Informal document GRSP-49-31  
(49th GRSP, 16-20 May 2011,  
agenda items 4(c))

Pedestrian Safety

# Request For Clarification Of Test Procedures

49<sup>th</sup> Session of UNECE GRSP,  
Geneva, 16 – 20 May 2011

Drawing: gtr No. 9, part B, figure 6

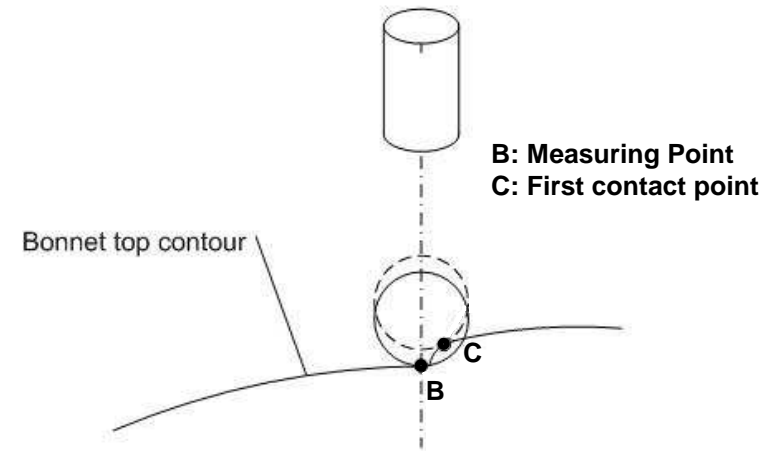
- A second drawing should be added to describe the three-dimensional interaction of the points
- The three different points need to be clearly described

Point B should read „measuring point“

New, additional drawing:  
Schematic front view

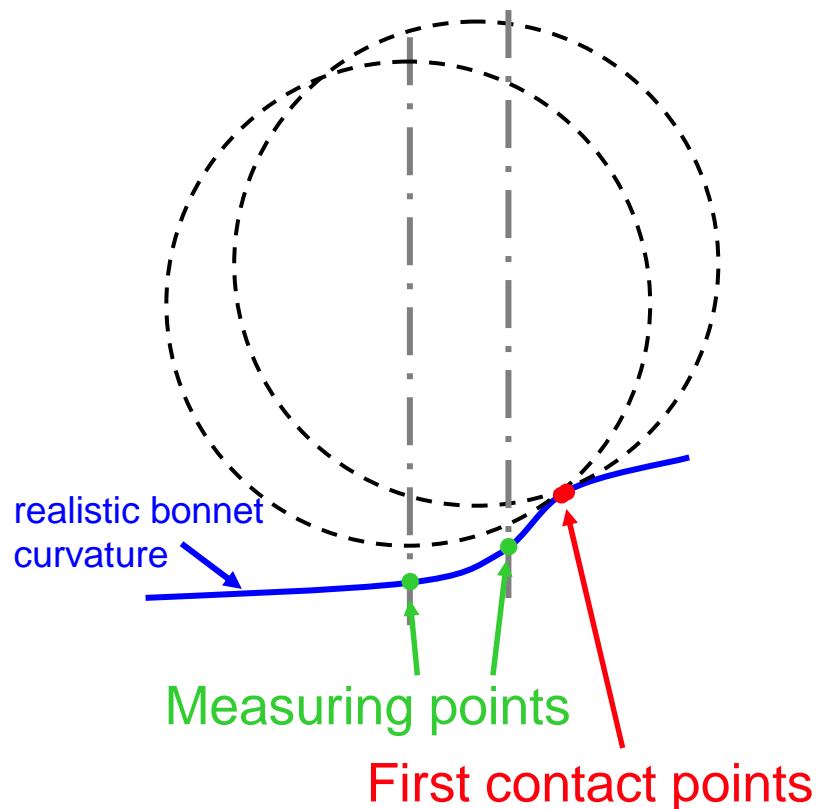
Point C should be added as „first contact point“

- In several cases, different terms are used to describe identical points
- Therefore, it is proposed to add the following references, e.g. to the definitions:
  - “Target point” A is also referred to as “aiming point”
  - “Measuring point” B is also referred to as “selected impact point” or “test point”
  - “First contact point” C is also referred to as “impact point”
- However, clear and easy understandable definitions are wished for by OICA to avoid misunderstandings

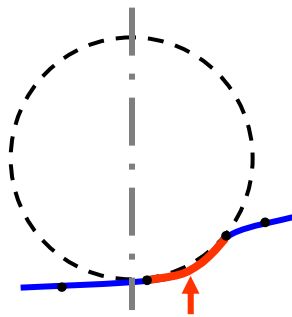
- It is unclear how to position the headform in relation to this point
- For very different impactor positions (as e.g. shown in the sketch) the first contact point could be nearly identical!
- However, headform center of gravity clearly influences the behavior of the headform during and after the impact
- Different HIC results can be possible
- Using the measuring points, a clear allocation of the test result is possible

Measuring points cannot be hit!

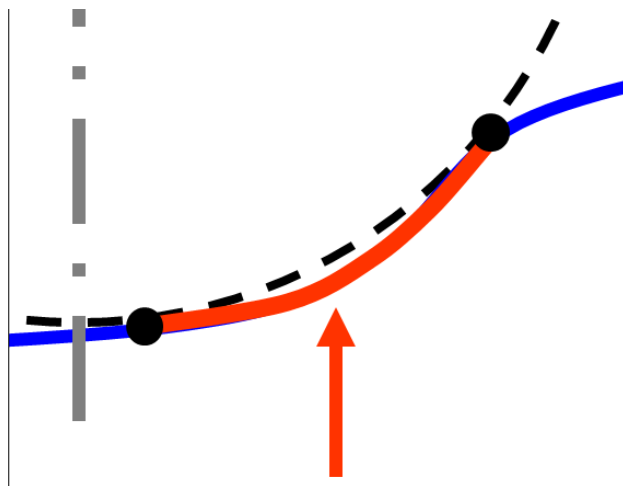
- There can be areas where a “measuring point” cannot be directly contacted, but:

- Clear positioning of the headform nevertheless possible
- Due to the headform’s center of gravity the headform will travel mainly in the intended direction
- Even if the same “first contact point” will be hit the resulting HIC can differ
- Areas that cannot be contacted may be misused as “black holes” preventing critical points from being tested
- Using the proposed procedure, each point on the bonnet that can be finger-pointed to will have an allocated test result!

Two first contact points

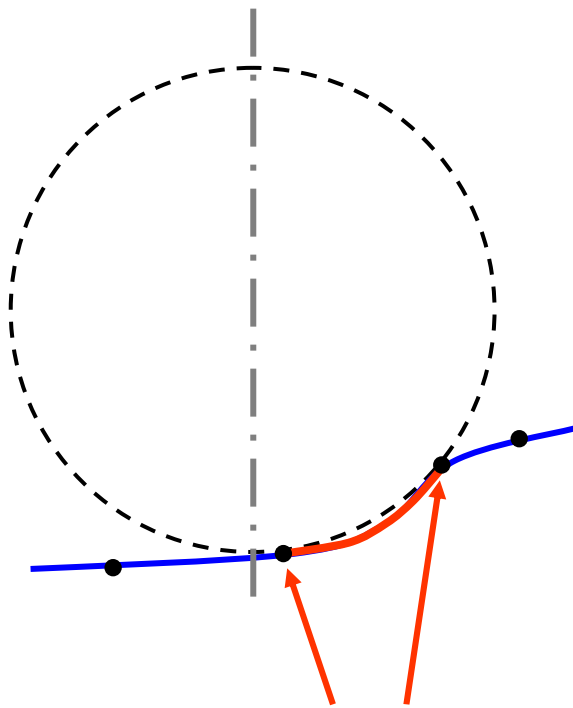
- There can be multiple contacts with 2 or even more “first contact points” hit during the same impact, but:

- Usually, kinetic energy is transferred in the plane of the headform’s center of gravity
- Independent of the number of first contact points: There will be just one calculated HIC result achieved
- Using the proposed procedure, the test result will be allocated to the point that was assigned as measuring point!

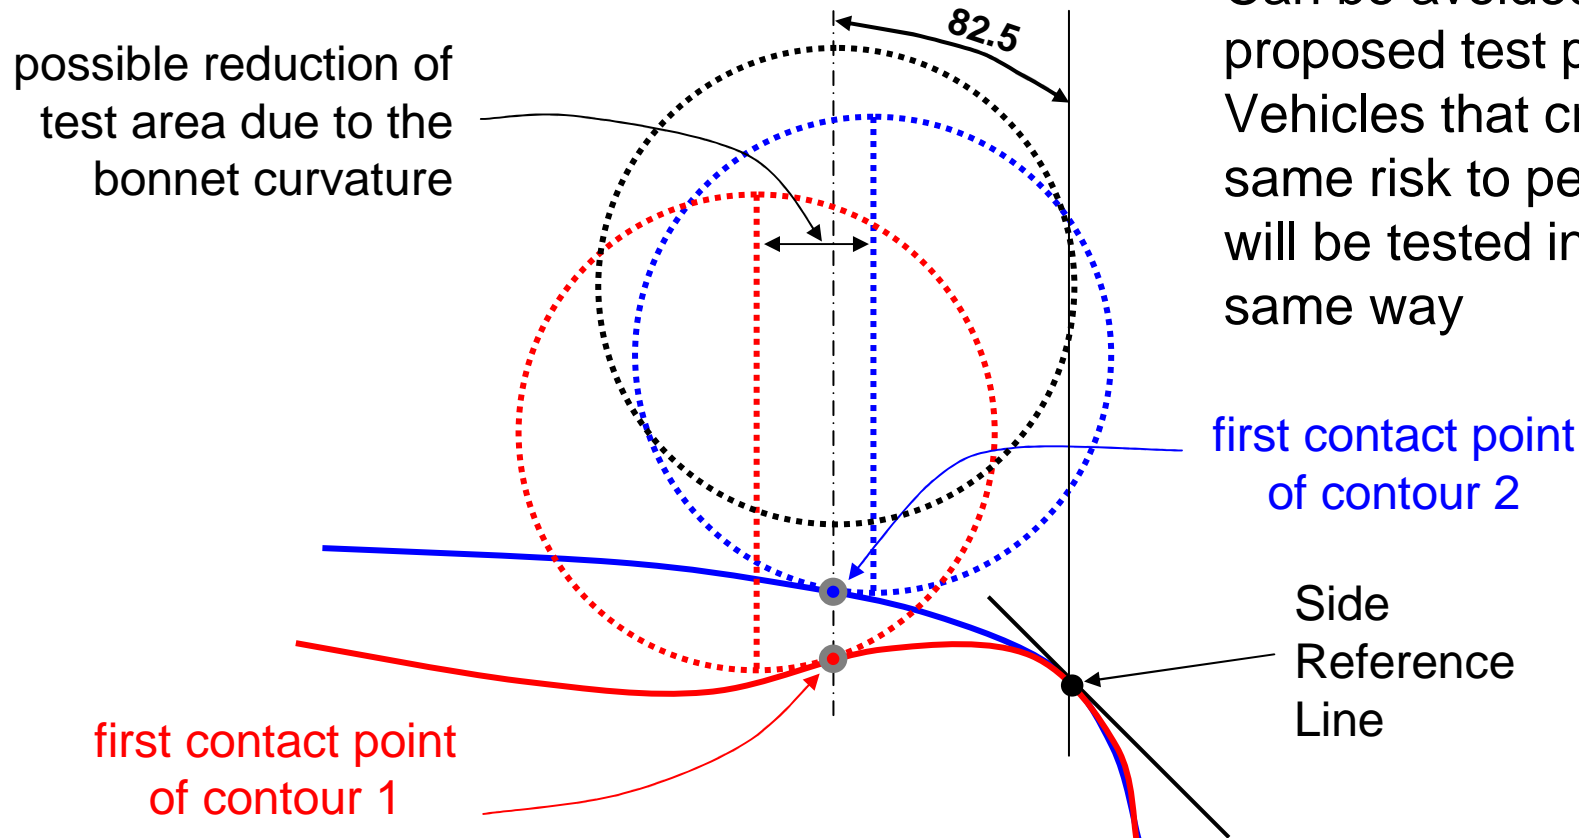
- Vehicles with an identical overall width but with different bonnet designs will be tested differently:

- Can be avoided with the proposed test procedure: Vehicles that create the same risk to pedestrians will be tested in the same way

Example for HIC zones using the 1/3 // 2/3 split (areas to be defined by the manufacturer)

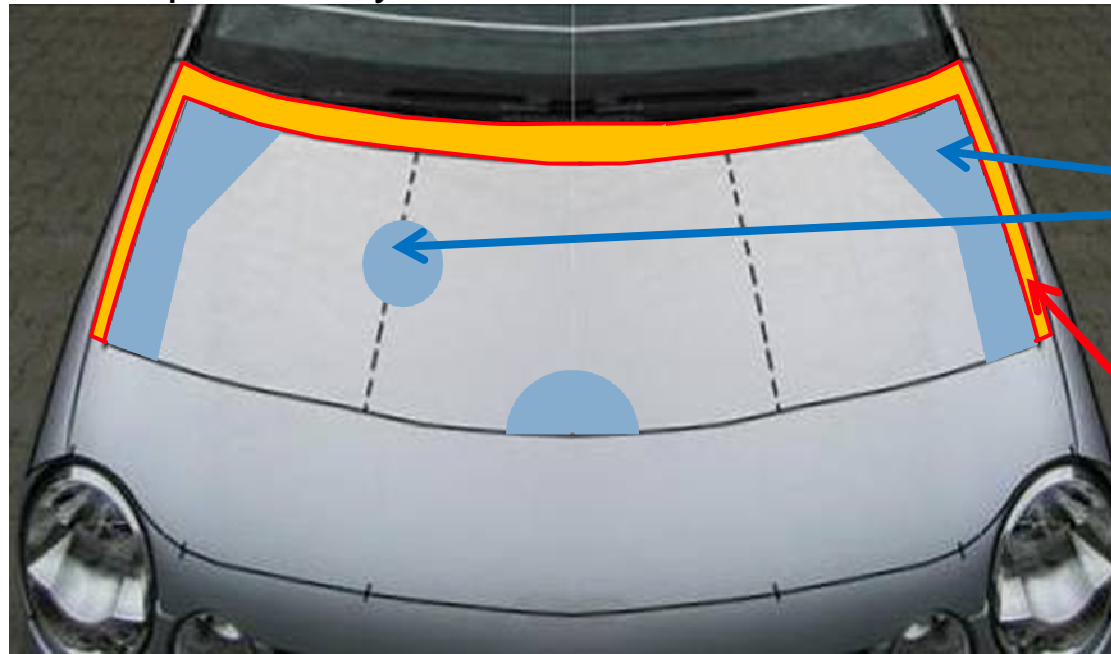
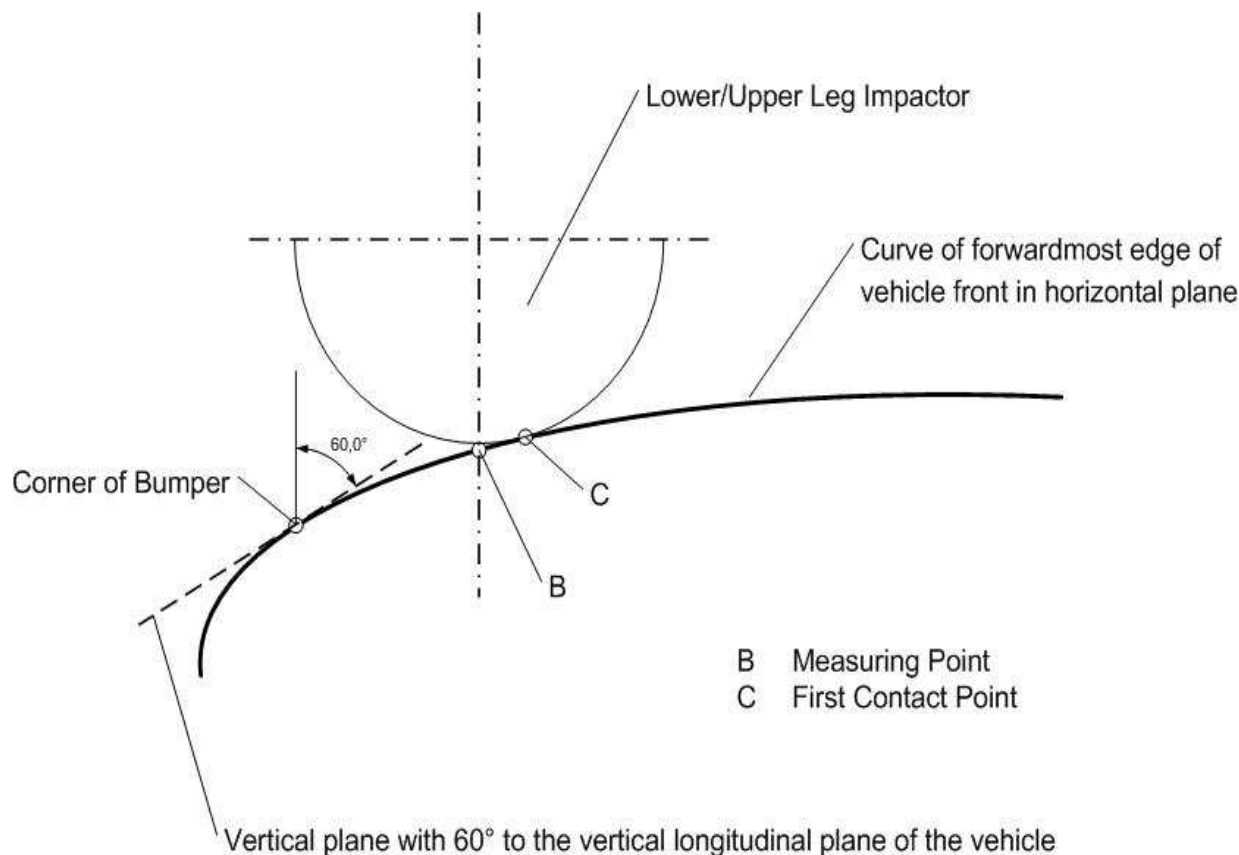
- A much larger HIC1700 zone will result (that may be spread in the testable area) from considering the offset area during the calculation of the HIC zones

- Using the proposed procedure, this will not be possible

Offset area: No test!

- The  $\frac{1}{2}$  headform diameter (82.5 mm) offset area should be excluded from the area used for HIC zones calculation
- Tests should be conducted to the same area
